nd Management Parameters for 10 Mb/s Operation and Associated Power Delivery over a Single Balance

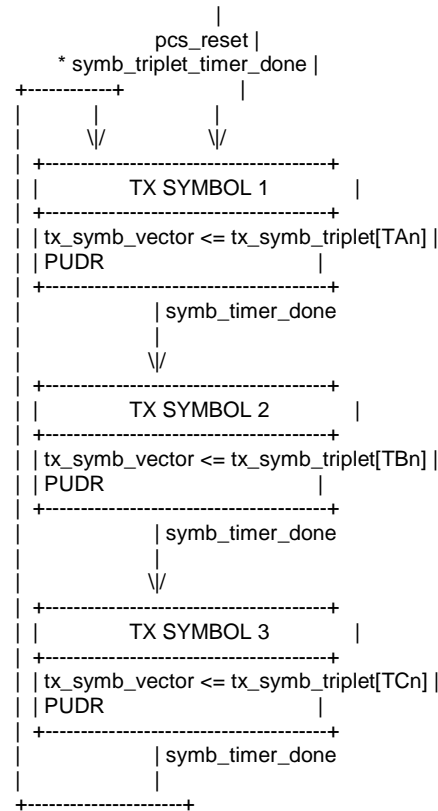
Is it correct that 'The PCS Transmit function shall conform to the PCS Transmit state diagram in Figure 146-5 ...' and that 'In each symbol period, PCS Transmit generates a symbol An provided to the PMA ...'? The PCS Transmit state diagram in Figure 146-5 changes state based on STD being true, with STD being an alias for symb_triplet_timer_done, and the output of the PCS Transmit state diagram is tx_symb_triplet which is defined in subclause 146.3.3.1.1 'Variables' as 'A triplet of ternary symbols generated by the PCS Transmit function after 4B3T encoding.'

I think the problem is that there is another function within the PCS Transmit function that is missing from the PCS Transmit state diagram in Figure 146-5, the 'multiplexor' shown in Figure 146-6 'PCS transmit symbol generation'. This 'multiplexor' function operates at the symbol clock rate and serialises the tx_symb_triplet code-groups output by the PCS Transmit state diagram into individual symbols.

This may also explain when subclause 146.3.3.1.3 'Timers' defines the symb_timer that is not used in the PCS Transmit state diagram in Figure 146-5.

[4] Add a new subclause 146.3.3.2.2 titled 'Timers'. Move the symb_timer definition from subclause 146.3.3.1.3 Timers to this new subclause.

[6] Insert a new Figure 145-6 shown below (view using a non-proportional font such as courier), renumbering the following figures as required.

[7] Add text to subclause 146.3.3 'PCS Transmit' that reads 'The PCS Transmit function shall conform to the PCS Transmit state diagram in in Figure 146-5 and the PCS Transmit multiplexor state diagram in 146-6, and their associated state variables, functions, timers, and messages.'
